CITY PLANNING COMMISSION

- APPLICATION:
1. Environmental Determination
 2. Tentative Map to divide 17.4± vacant acres into 7 lots in the Townhouse-Planned Unit Development (R-1A(PUD)) zone.
 3. Special Permit to develop 250 condominium units known as Gateway Oaks, Unit 2 (Zon. Ord., Sec. 8-B-3)

APPLC. NO. P84-117

MEETING DATE April 26, 1984

TENTATIVE MAP
GATEWAY OAKS CONDOMINIUMS
UNIT 2
RIVER RIDGE
CITY OF SACRAMENTO CALIFORNIA
MARCH 1984

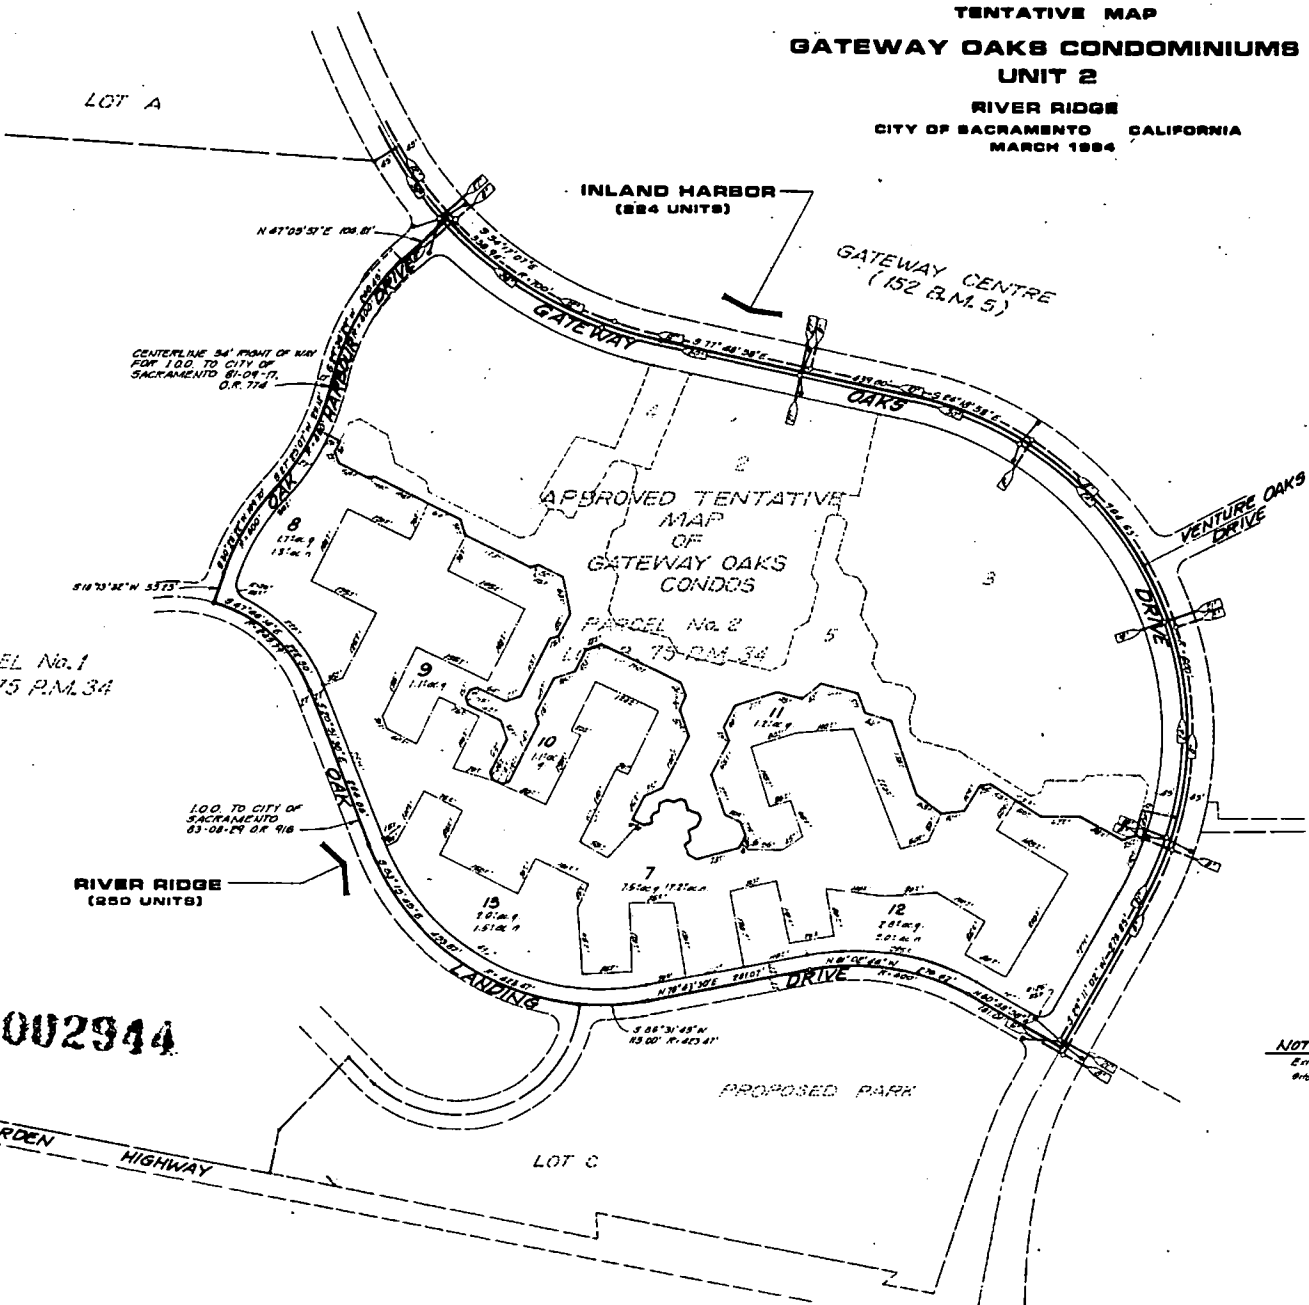
SUBDIVISION REVIEW COMMITTEE RECOMMENDATION: On April 11, 1984, by a vote of seven ayes, two absent, the Subdivision Review Committee voted to recommend approval of the tentative map, subject to the following conditions. The applicant shall satisfy each of the following conditions prior to filing the final map unless a different time for compliance is specifically noted:

- a. Prepare a sewer and drainage study for the review and approval of the City Engineer;
- b. Pursuant to City Code Section 40.319-1, the applicant shall indicate easements on the final map to allow for the placement of centralized mail delivery units. The specific locations for such easements shall be subject to review and approval of the City Engineer after consultation with the U.S. Postal Service;

- c. The applicant/developer shall designate and place on the final map those structures and/or lots which will meet the required 80% south orientation (including solar access) to the satisfaction of the Planning Director, or comply with Title 24 requirements of the Uniform Building Code;

- d. Provide reciprocal sewer, water, drainage and access easements as required;
- e. Place the following notes on the final map:
 - 1) the lake shall be privately maintained; water supply shall be from private wells;

- 2) one homeowners' association shall be formed for all property surrounding the lake (P83-385, Gateway Oaks Condominiums, Unit 1) and CC and R's developed designating responsibility for maintenance of the lake assigned to the homeowners' association. The CC and R's shall be approved by the Public Works Director and the City Attorney prior to issuance of building permits.

ANTHONY M. GUZZARO AND ASSOCIATES INC. LANDSCAPE ARCHITECTS 224 W. HARRISON ST. SACRAMENTO, CALIFORNIA
 RIVER RIDGE CALIFORNIA
 CONCEPTUAL LANDSCAPE PLAN
 SCALE 1"=40'
 DATE 11/94
 SHEET 1 OF 2

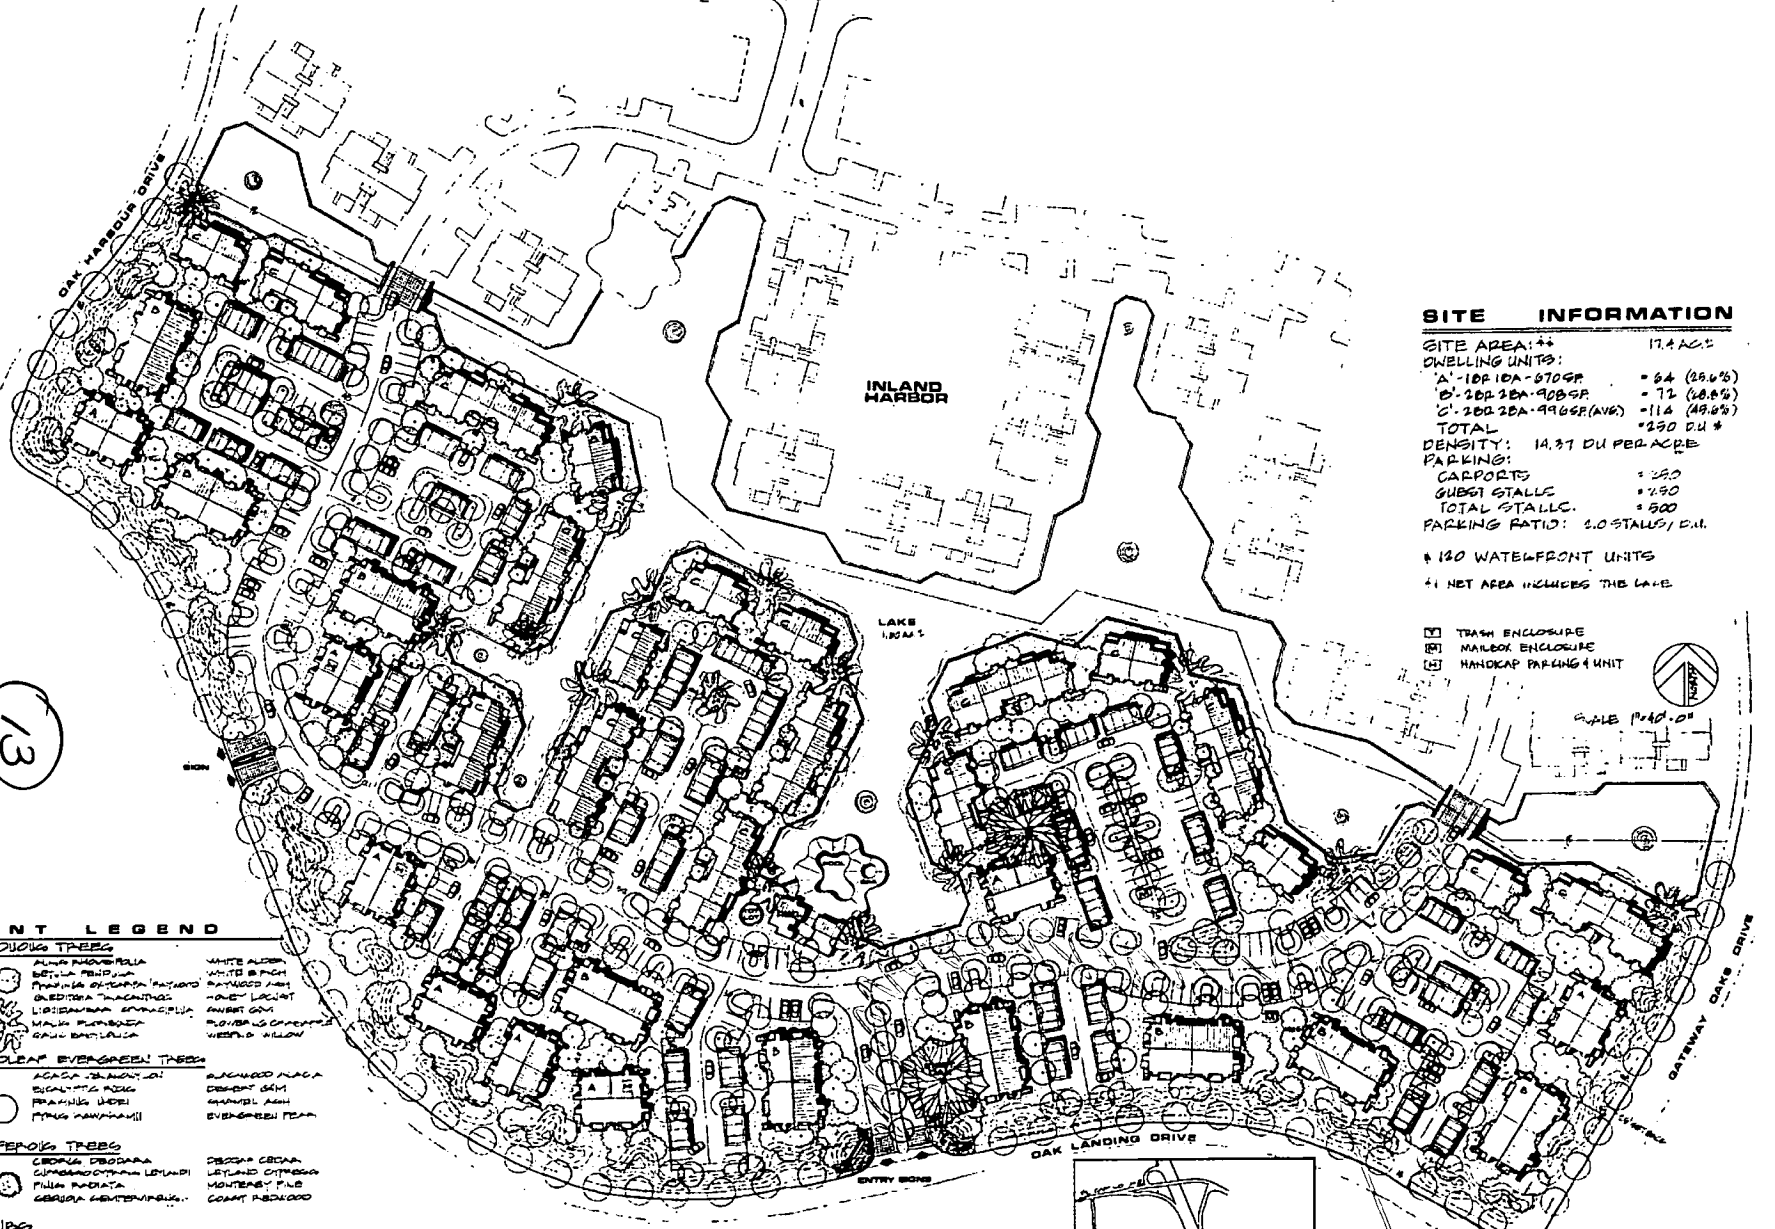
The proposed project provides landscape setbacks of 25 feet to 40 feet along Oak Landing and Oak Harbor Drives. The project provides off-street parking at a ratio of two spaces per unit. One-half of the spaces is covered. To insure consistency in landscape development throughout the project, and the incorporation of energy saving design elements in the site design, staff recommends that Exhibit A be adopted as a condition of approval.

- a. The applicant shall adhere to the residential design criteria as outlined in Exhibit A;
- b. The applicant shall submit a sample color board for the Phase II units to the Planning Director for review and approval prior to issuance of building permit;
- c. A detailed landscape and irrigation plan shall be submitted for staff review and approval prior to the issuance of building permits. This plan shall incorporate the design elements as set forth in Exhibit A;
- d. The applicant shall submit a sample of the roofing materials to the Planning Director for review and approval prior to issuance of building permit;
- e. A homeowners' association shall be formed and CC and R's developed assigning responsibility of maintenance of the lake area to the homeowners' association. CC and R's shall be approved by the Public Works Director and City Attorney.
